December 29, 2025

CONTRACT NO. 1797

OHIO RIVER TUNNEL

ADDENDUM No. 11

ORT-ST-300 A48 DROP SHAFT SUPPORT OF EXCAVATION SHEET 1 OF 2

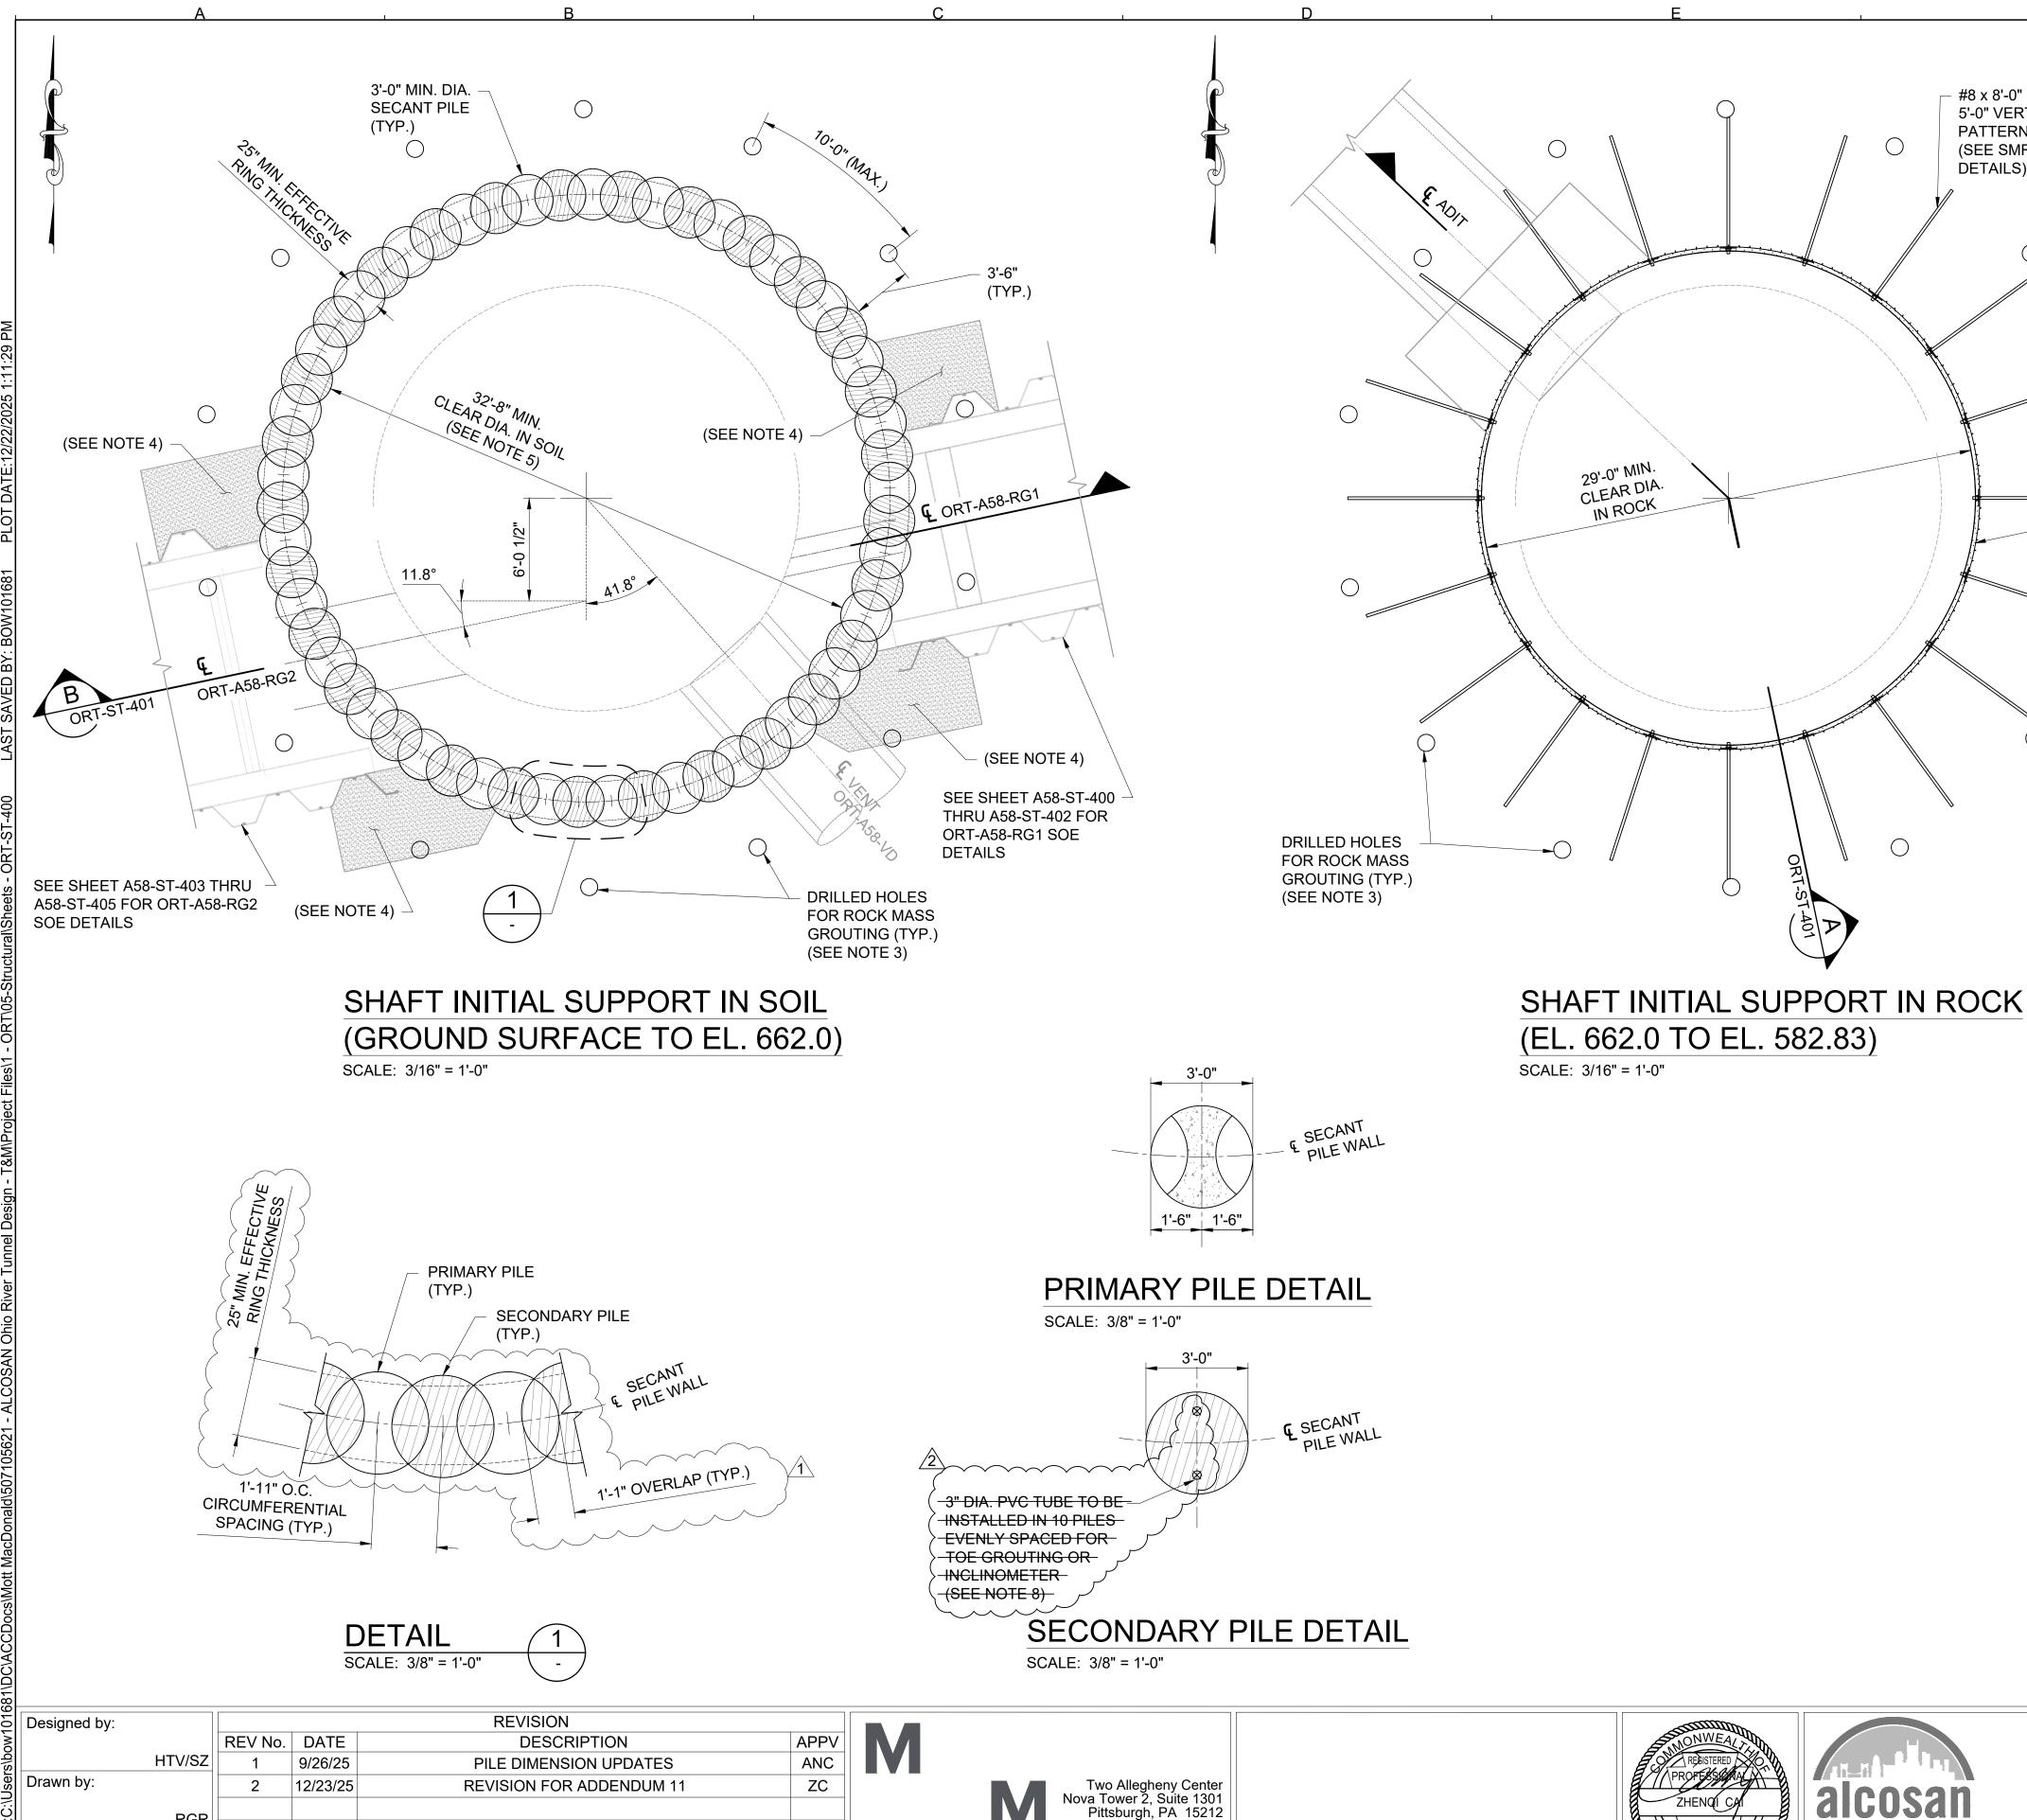
- Q38 See the following Drawings:
 - Drawing ORT-ST-200, Note #8, (O41 Drop Shaft)
 - Drawing ORT-ST-300, Note #8, (A48 Drop Shaft)
 - Drawing ORT-ST-400, Note #8, (A58 Drop Shaft)
 - Drawing ORT-ST-600, Note #8, (O14 Drop Shaft)
 - Drawing ORT-ST-700, Note #8, (O07 Drop Shaft)
 - Drawing ORT-ST-800, Note #8, (O06A Drop Shaft)

These notes state "CONTRACTOR SHALL PROVIDE THE NECESSARY REINFORCEMENT OR CENTRALIZERS TO SUPPORT AND MAINTAIN THE TOE GROUTING PVC PIPES AND INCLINOMETER CASINGS IN PLACE WHILE POURING CONCRETE IN SECONDARY PILES."

- Answer to Questions #1 and #2: Note 8 on these drawings have been removed. As stated in Section 31 57 00 (Secant Pile Wall) Part 1.6.D.8, the Contractor shall submit "Procedures and mix designs for grouting of the toe of the secant piles to seal the secant pile wall/ground interface, where applicable." Refer to Addendum 009, Q15/A15 for additional information. See Section B Item 16 and Attachment I for Changes to Contract Documents.
